LOW PRESSURE BALANCED CONTROL VALVE

Product Improvements

This notice is to inform you that we have made the following improvements to **2" and 3" Kimray Low Pressure Balanced Control Valves**. These key updates mean your valves will stand up better in harsh conditions while allowing you increased flexibility and faster repair.

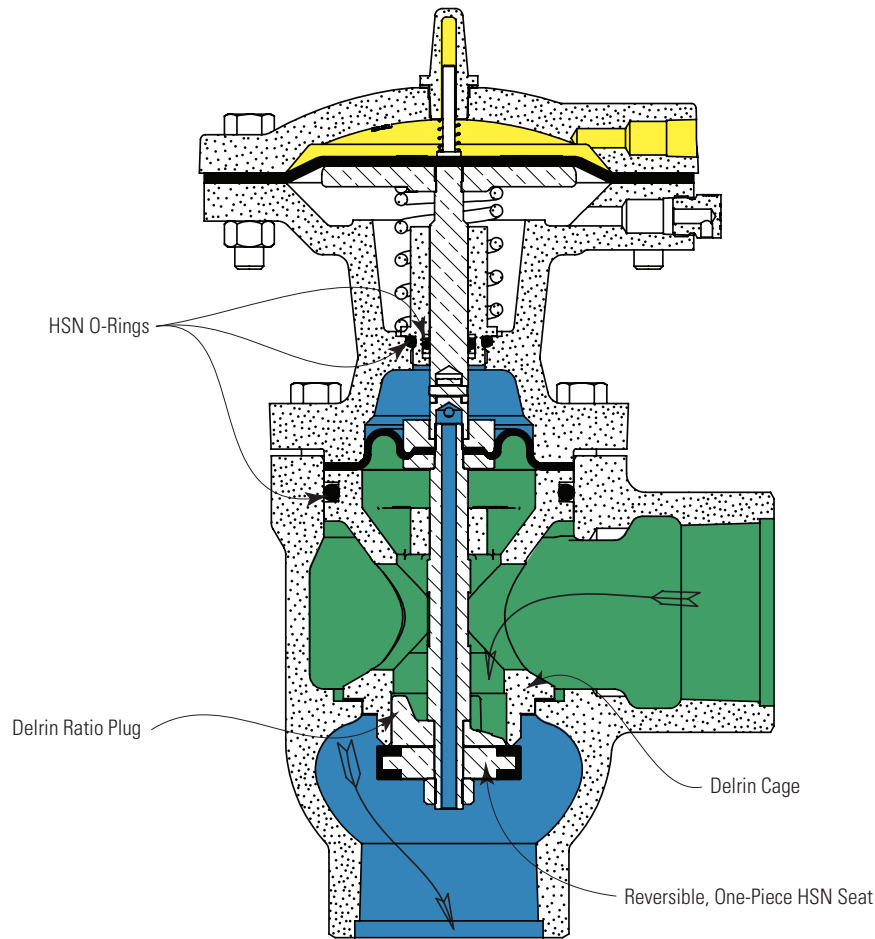
2" and 3" Low Pressure Balanced Control Valves will feature the following changes:

Reversible one-piece HSN seat with metal insert in diaphragm-balanced and piston-balanced models

Delrin ratio plug in diaphragm-balanced and piston-balanced models

Delrin cage in diaphragm-balanced model only

All O-rings changed to HSN
